Our ref: 12791
Council ref: A006924541

RE: RESPONSE TO INFORMATION REQUEST SECTION 13.2 OF THE DEVELOPMENT ASSESSMENT RULES FOR DEVELOPMENT PERMIT FOR A CHANGE APPLICATION (OTHER CHANGE) – MATERIAL CHANGE OF USE – FOOD AND DRINK OUTLET OVER 1840 WYNNUM ROAD WYNNUM WEST QLD 4178 FORMALLY KNOWN AS LOT 1 ON RP155373

Figure 3: Proposed Site Plan – Bayer Stevens

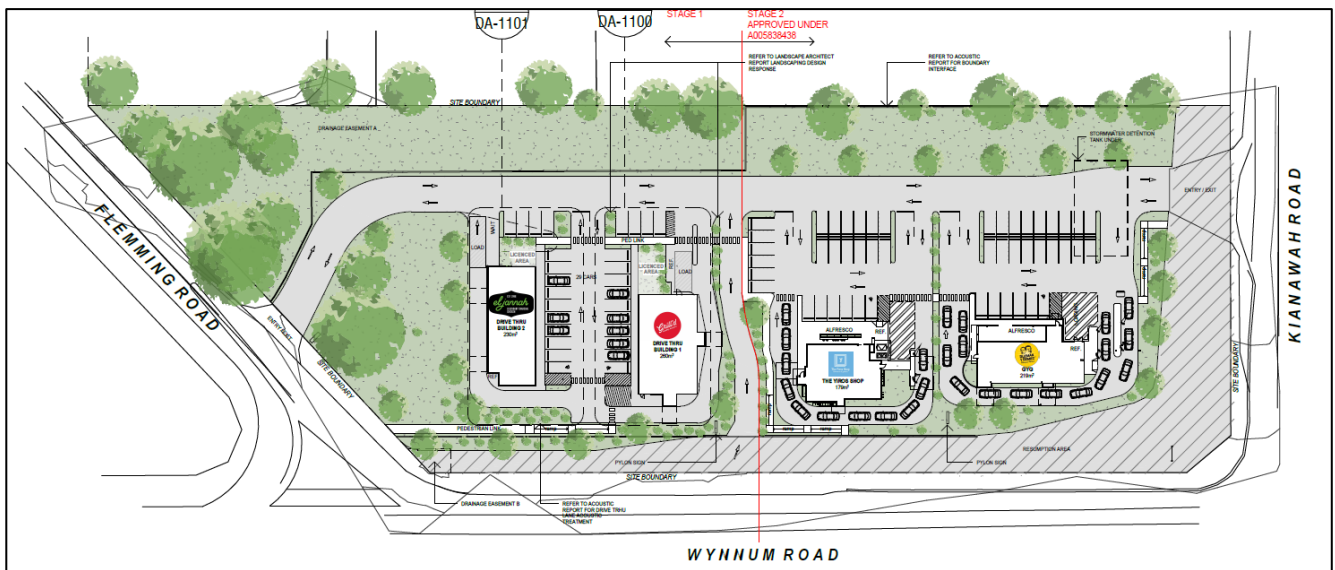
- a) *Provide amended plans showing reduced number of food and drink tenancies that may be more consistent with the intended form, character and intensity of the immediate and local area to comply with Overall outcome 3(c), 3(f) of Hemmant – Lytton neighbourhood plan code and Overall outcome 2(c), 2(d), 2(j) and 2(k) of the Rural residential zone code and PO1 of the Centre or mixed use code.*

The proposed development has reduced the GFA of the proposed tenancies (reduction of 60m² in total for Stage 2), reducing the built form further, please see **Attachment A** – Proposal Plan prepared by Bayer Studios. The landscaping has been enhanced to increase streetscape appeal when viewed from Fleming Road and Wynnum Road. Pedestrian links within the site have been emphasised to ensure a smooth transition from public to private space.

Figure 8 – Pedestrian Circulation - Bayer Stevens

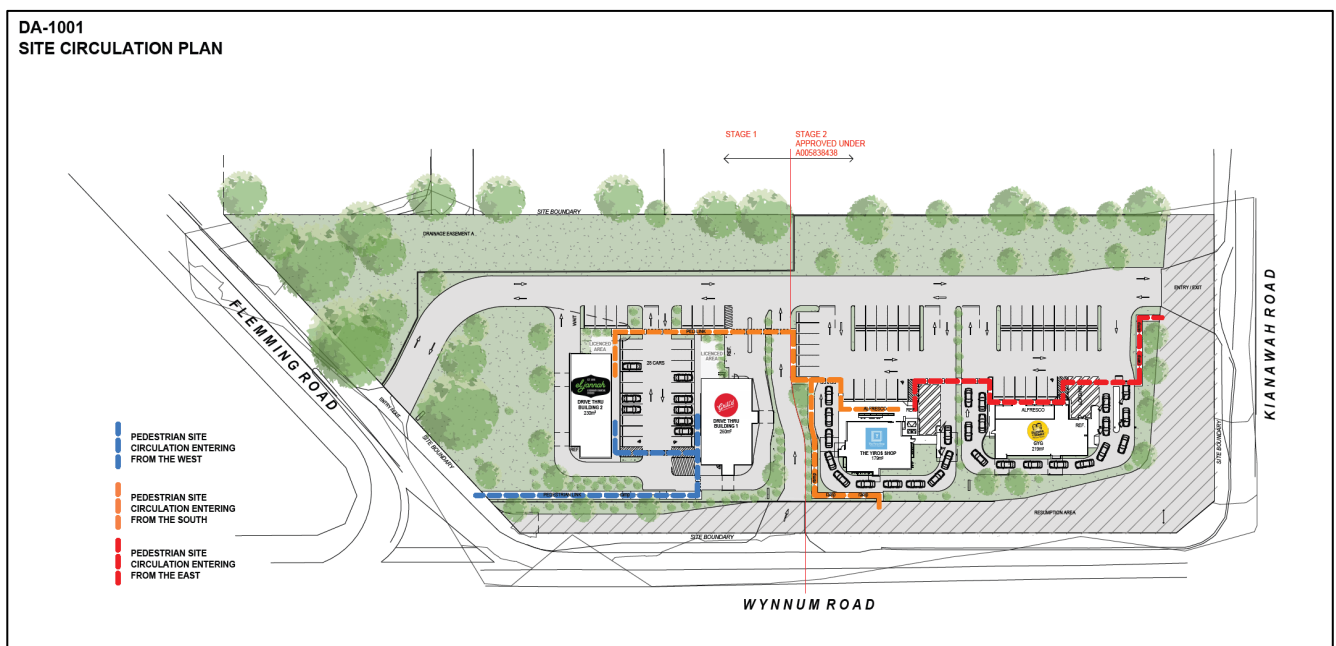
6. *The current design does not appropriately locate outdoor dining area to enhance the public realm in accordance with AO7 of the Centre or mixed use code. Additionally, the proposal results in minimum of 2 'road' crossings through car movement zones due to the sub-optimal arrangements of the pedestrian pathway, that does not address pedestrian connectivity, movement, and safety from the street to the buildings, as per AO45 of the Centre or mixed use code.*

a) *Submit amended built form configuration that locates the drive through circulation behind the buildings allowing for connection of the public realm to the entry points, outdoor dining, and building directly from the street to the buildings, and without the need to pass through car dominated areas for safe pedestrian movement.*

Please see **Attachment A** – Architectural Plans prepared by Bayer Stevens which has introduced a Site Circulation Plan, showing pedestrian movements moving fluidly through the site from Kianawah Road, Wynnum Road and Fleming Road frontages.

Additionally, the loading for the drive-thru is relocated to remove conflicts.

Figure 10 – Revised Landscape Design – Saunders Havill

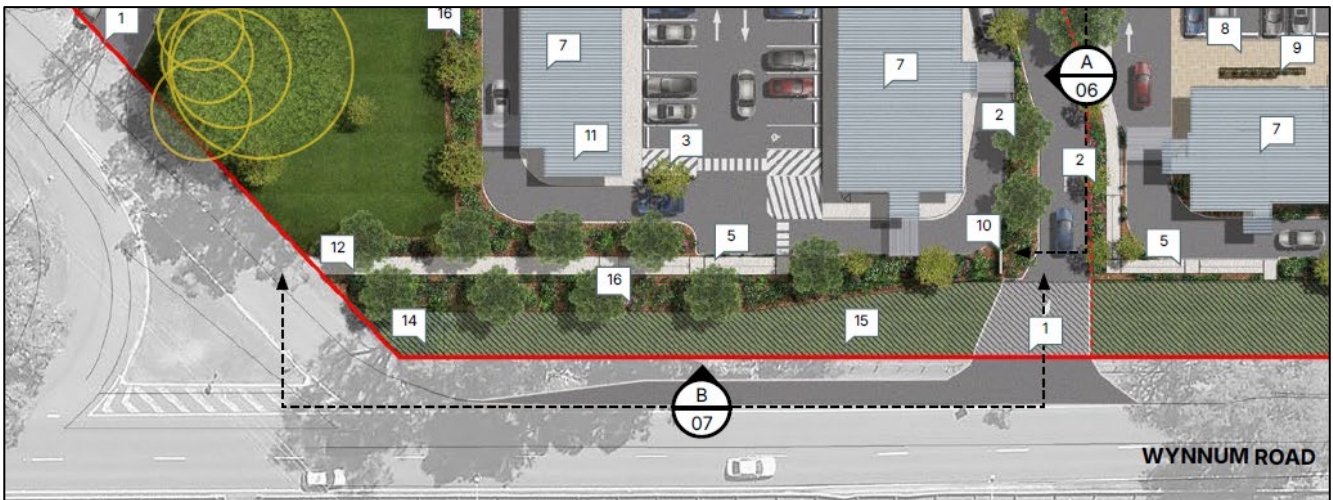
10. *The provided Landscape Concept Plan indicates a narrow landscape buffer that lacks any shade trees along the edge of the pedestrian path on the frontage, to effectively screen or soften the significant hardstand and car parking area from the streetscape. Provide an amended Landscape Concept Plan that increases the landscape buffer along the edge of the pedestrian path to a minimum of 2m and incorporate large subtropical shade tree planting and a varied palette of shrubs and groundcovers, to contribute to a comfortable pedestrian environment or support a high level of subtropical amenity in accordance with PO55, PO56, PO57 and PO58 of the Centre or mixed use code.*

Please see **Attachment A & I** – Architectural Plans and Landscape Concept Plan prepared by Bayer Stevens and Saunders Havill. During the meeting with Brisbane City Council, we understand pedestrian permeability between public and private space is a priority. The applicant has amended the design along Wynnum Road with additional planting to buffer the drive-thru area to incorporate safer design practices for pedestrian movements. Larger subtropical shade trees have been incorporated into the deep planting areas to soften the hardstand areas and the built form from all road frontages.

Figure 11 – Previous Approved Vegetation Management Plan – S5 Environmental

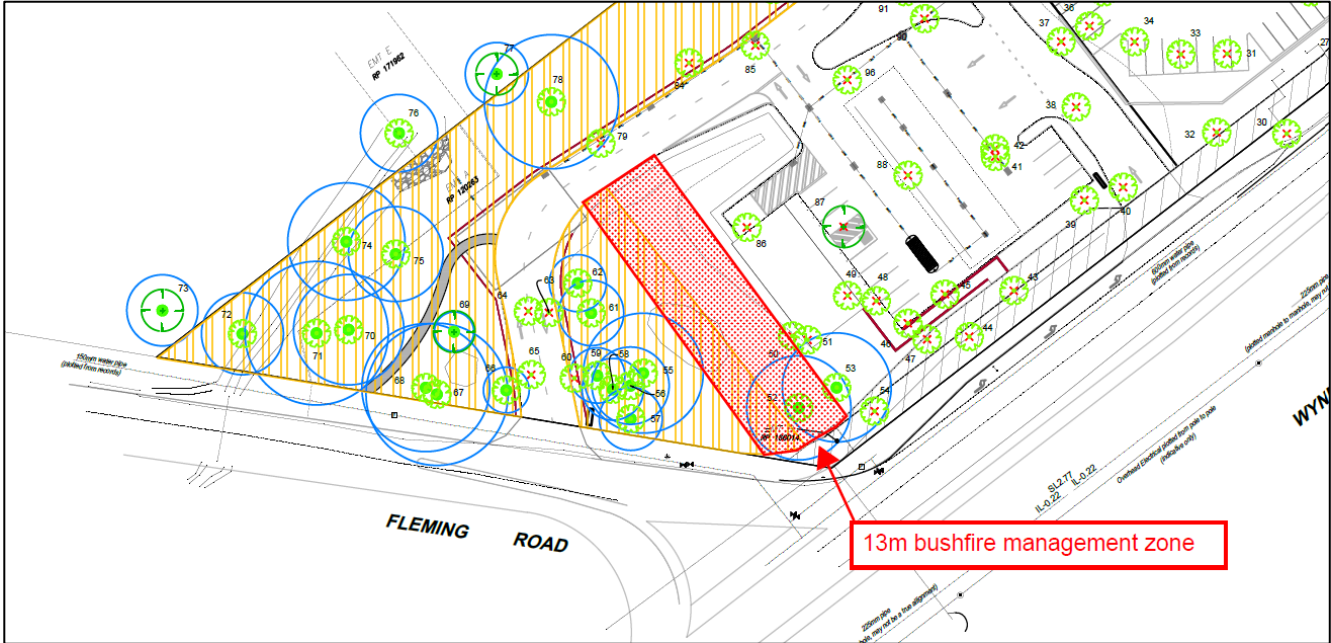
12. *The revised development layout will result in changes to previously approved plans that identify vegetation for retention/removal and rehabilitation areas, likely resulting in a reduced impact to these values. Additionally, the submitted plans do not identify the approved 13m bushfire management setback that was shown on previously approved plans and conditioned bushfire management setback that was shown on previously approved plans and conditioned.*

- a) *Provide revised Tree Retention/Removal Plans and Concept Rehabilitation Plan demonstrating that the proposed development will not result in any additional impact to existing ecological values within mapped areas of high ecological significance/high ecological significance- strategic. Revised plans must also identify the required 13m setback from potentially hazardous vegetation, in accordance with previous approvals.*

The proposed development generally follows the original development footprint, with the exception of a small portion of the El Jannah Food and Drink Outlet, please see the screenshot below of the dotted outline of the previous approved footprint.

Within this revised development footprint, as shown in the screenshot below from the Approved Vegetation Management Plan prepared by S5 Environmental, there are no trees in the expansion of the existing footprint. There is no further requirement for an amended Tree Retention Removal Plan as this does not alter the originally approved trees to be retained and removed, please see the screenshot below from the Approved Vegetation Management Plan.
